Town of Hilton Head Island Regular Design Review Board Meeting

Project: DRB Final Review, Vacation Homes of Hilton Head, Hilton Head Island, SC

DESIGN TEAM/DRB COMMENT SHEET

DATE: Oct 12, 2018 **Revised Oct. 16, 2018**

SHEET: **L1**

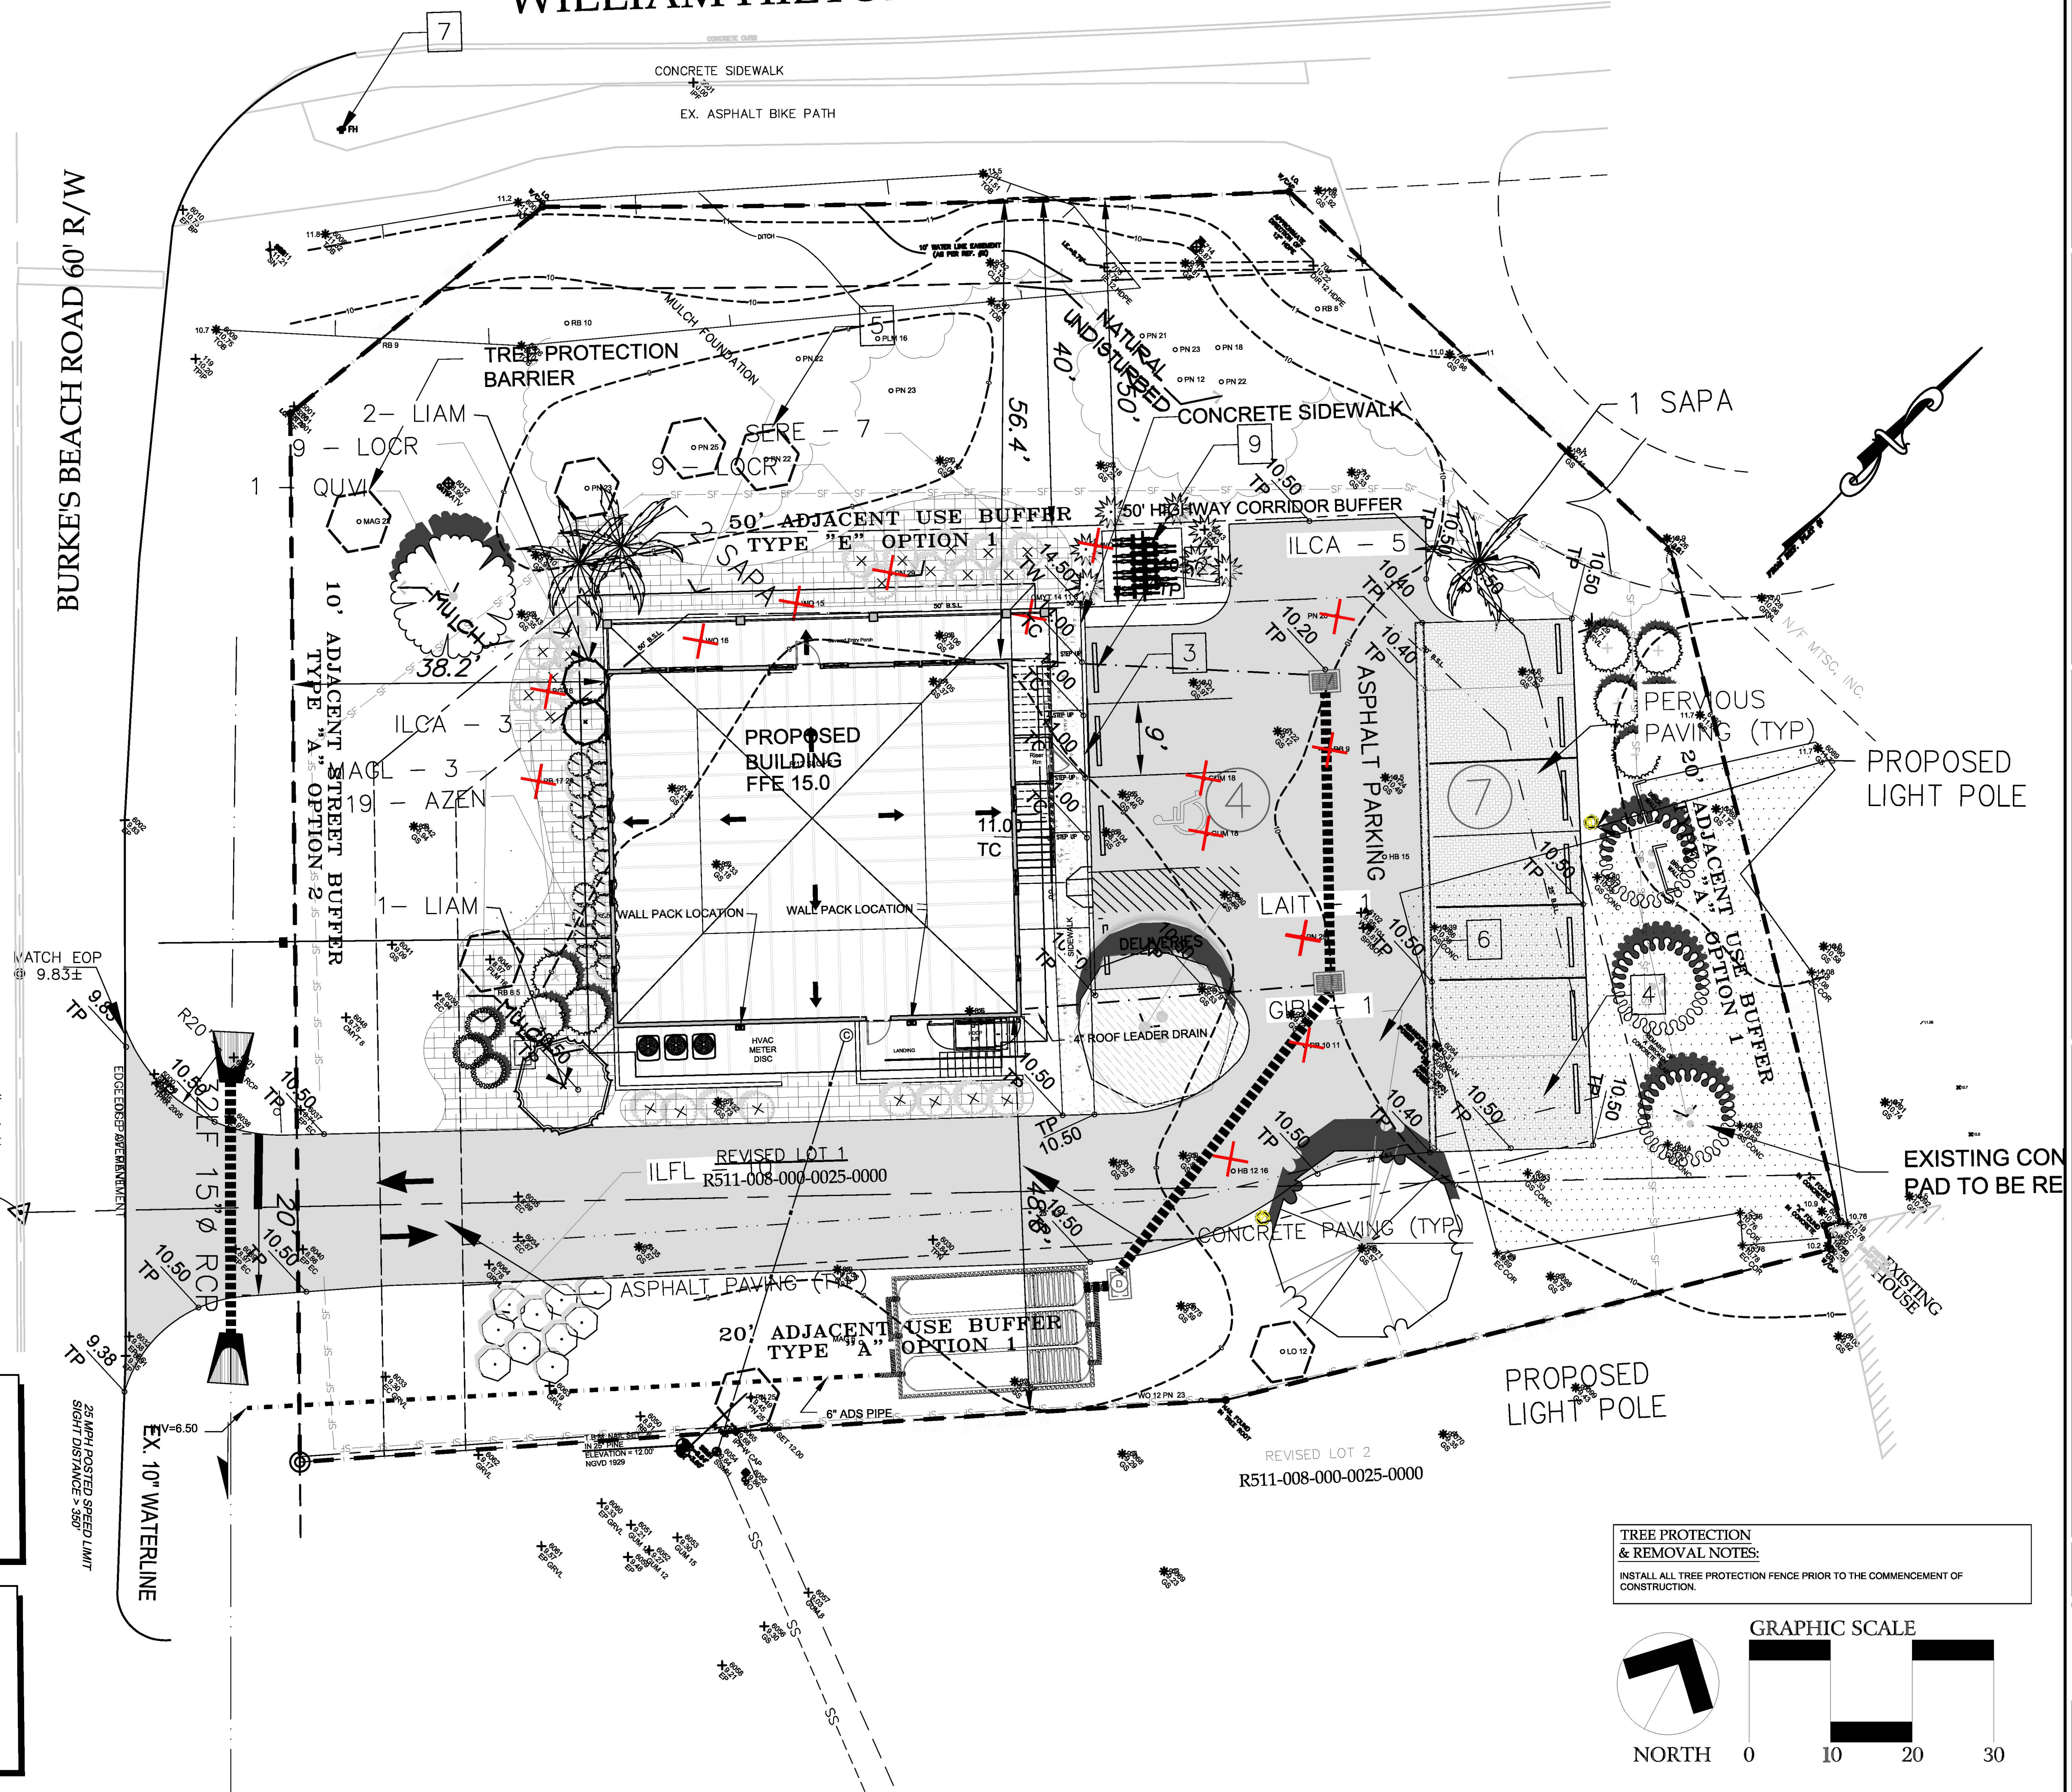
1. Provide a Demolition Plan. **Note to remove existing slab clipped on Landscape Plan**
2. ~~Select a wall sconce that shields the light source from view.~~ **Done**

3. Revise the tree protection to include understory growth in the buffers. **Silt fence should be behind Burkes Beach Road Buffer to protect understory vegetation.**

4. Revise the Planting Plan:
 - a. ~~Includes a Plant Schedule.~~ **Done**
 - b. ~~Includes existing understory plants.~~ **Done**
 - c. Compliments the architecture. **Shrubs at porch will get too large, Crepe Myrtle on Burkes Beach Road side are too close to the building, Magnolia at Burkes Beach are too close to each other.**

- d. Does not block site amenities. **With proposed planting bike rack is inaccessible.**
 - e. Includes a planted screen along the driveway. **Add planting (that will grow to large shrubs or small trees) between buffer and drive to supplement the existing buffer vegetation.**

LANDSCAPE DESIGN				
DESIGN GUIDE/LMO CRITERIA	Complies Yes	No	Not Applicable	Comments or Conditions
Treats the Landscape as a major element of the project	<input type="checkbox"/>	<input checked="" type="checkbox"/>	<input type="checkbox"/>	There is no plant schedule.
Preserves a variety of existing native trees and shrubs	<input type="checkbox"/>	<input checked="" type="checkbox"/>	<input type="checkbox"/>	Tree protection fence should protect all the buffer along Hwy 278 and Burkes Beach Road. Existing understory vegetation should also be protected.
Provides for a harmonious setting for the site's structures, parking areas or other construction	<input type="checkbox"/>	<input type="checkbox"/>	<input type="checkbox"/>	
Location of existing trees and new trees provides street buffers, mitigation for parking lots, and an architectural complement that visually mitigates between parking lots and building(s)	<input type="checkbox"/>	<input checked="" type="checkbox"/>	<input type="checkbox"/>	<ol style="list-style-type: none"> Plantings do not compliment the architecture. Large shrubs planted in front of a low porch. Planting blocks bike racks.

Shrubs are selected to complement the natural setting, provide visual interest and screen less desirable elements of the project	<input type="checkbox"/>	<input checked="" type="checkbox"/>	<input type="checkbox"/>	Add plantings to improve screen along drive, perpendicular to Burkes Beach Rd.
Provides overall order and continuity of the Landscape plan	<input type="checkbox"/>	<input checked="" type="checkbox"/>	<input type="checkbox"/>	Proposed landscape seems random.
A variety of sizes is selected to create a "layered" appearance for visual interest and a sense of depth	<input type="checkbox"/>	<input checked="" type="checkbox"/>	<input type="checkbox"/>	No small shrubs or groundcovers.

Front Elevation

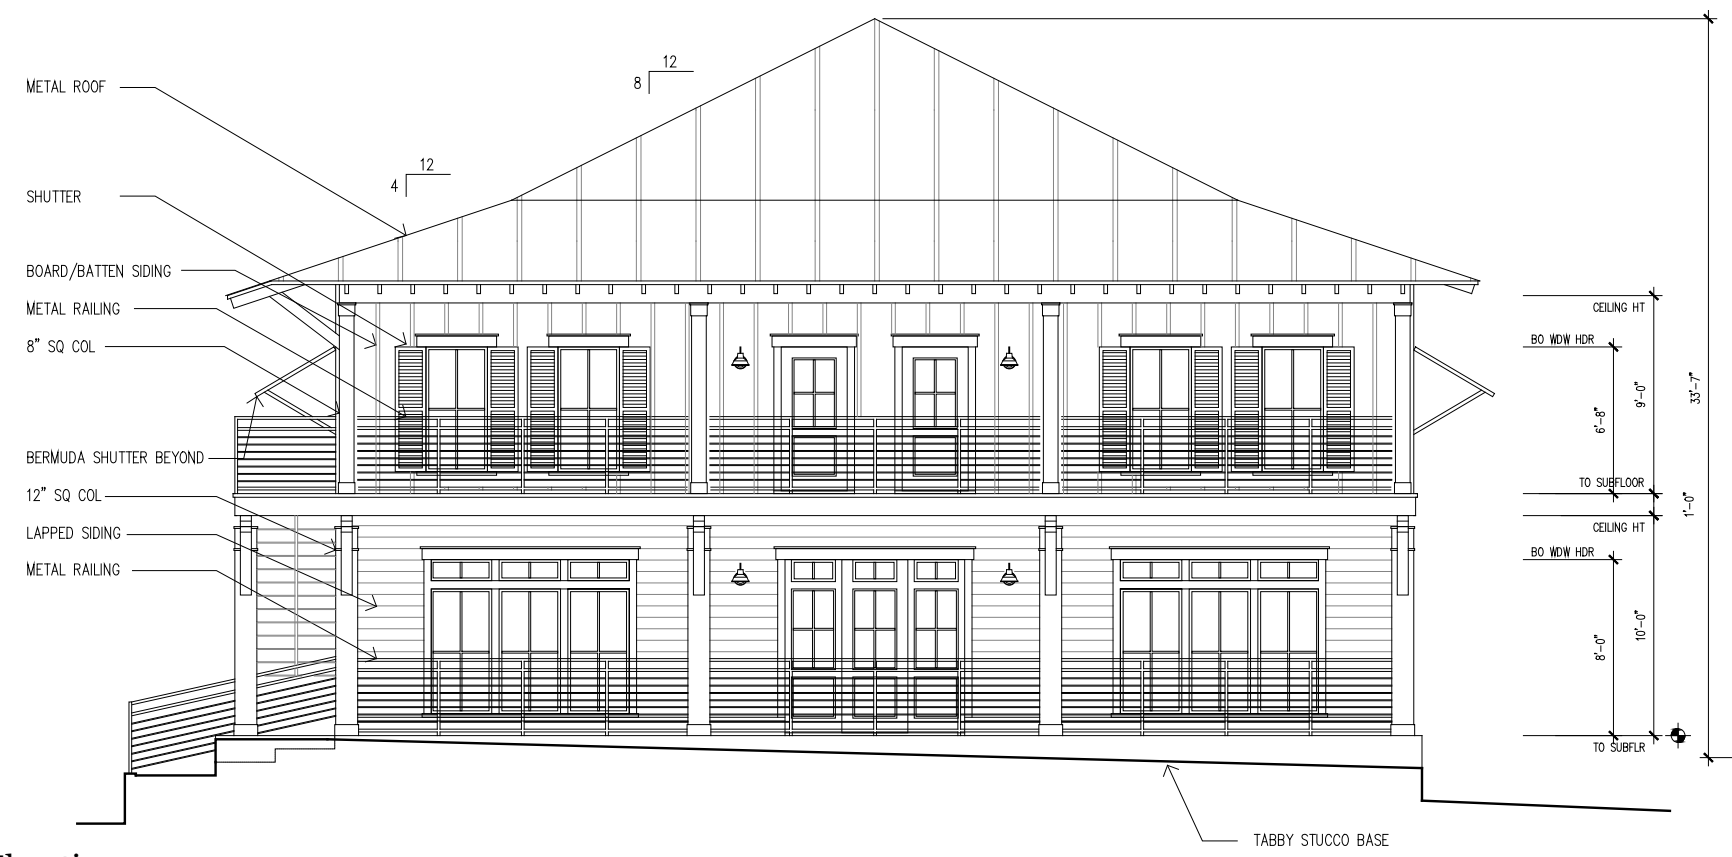
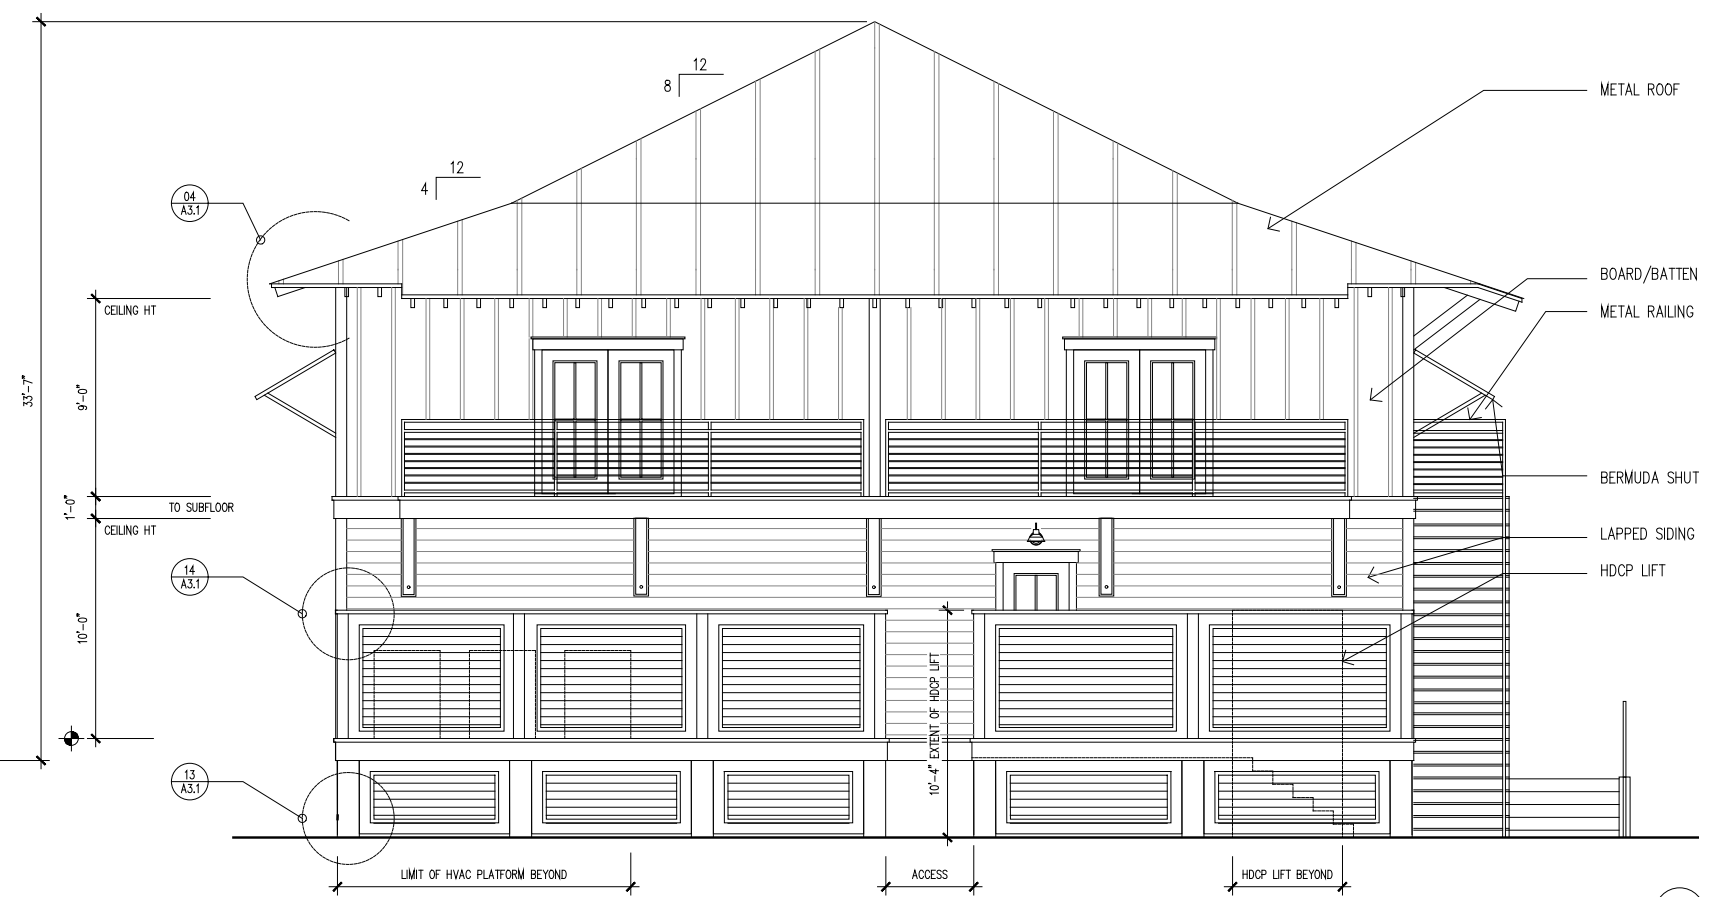
MISC COMMENTS/QUESTIONS
1. The "Ibis White" and "Marshmallow" are too light and bleach out visually to white in the sun. Select more nature blending colors.
2. The Landscape Plan is confusing and difficult to read. Staff is recommending "Denial" because the Landscape Plan does not meet requirements of the Design Guide (p. 20 –"emphasis must be given to overall order and continuity", p. 20 – "Proper spacing... to allow for plants to reach their mature size and natural shape".
3. How will the area from the proposed landscape bed edge to the edge of the path on Hwy 278 and the edge of Burkes Beach be treated?
